TO: ALL ROOTES GROUP DEALERS  
MODEL: SUNBEAM IMP  
SUBJECT: FRONT SUSPENSION KNOCK

7592

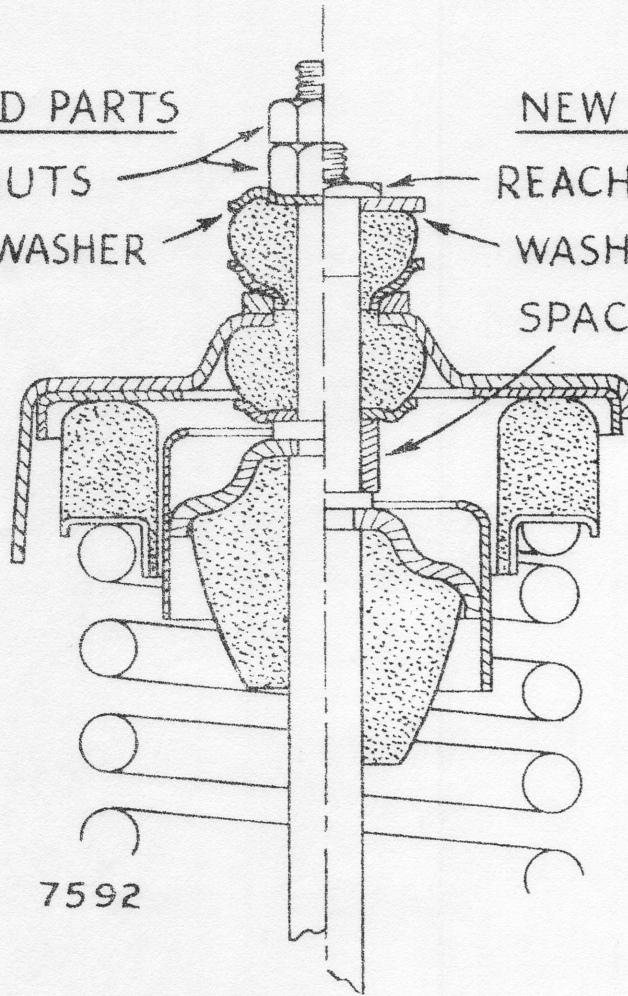
With the introduction of longer front suspension springs, the internal rebound travel in the shock absorbers was reduced. Whilst travelling over rough road surfaces in a lightly laden condition, a knock may be heard on full rebound.

- (1) Remove shock absorber.
- (2) Discard the TWO locknuts and TOP dished washer.
- (3) Fit the spacer provided on top of the collar as shown in the attached illustration.
- (4) Refit the remaining displaced parts in the reverse order to that in which they were removed.
- (5) In place of the discarded top dished washer and lock nuts, fit washer and reach nut, also shown in illustration.

To overcome this condition, it is recommended that kit, Part No. 7050100 is fitted to both front shock absorbers as follows:-

Spacer	-	Additional
Washer	-	Replaces top dished washer
Reach Nut	-	" both lock nuts
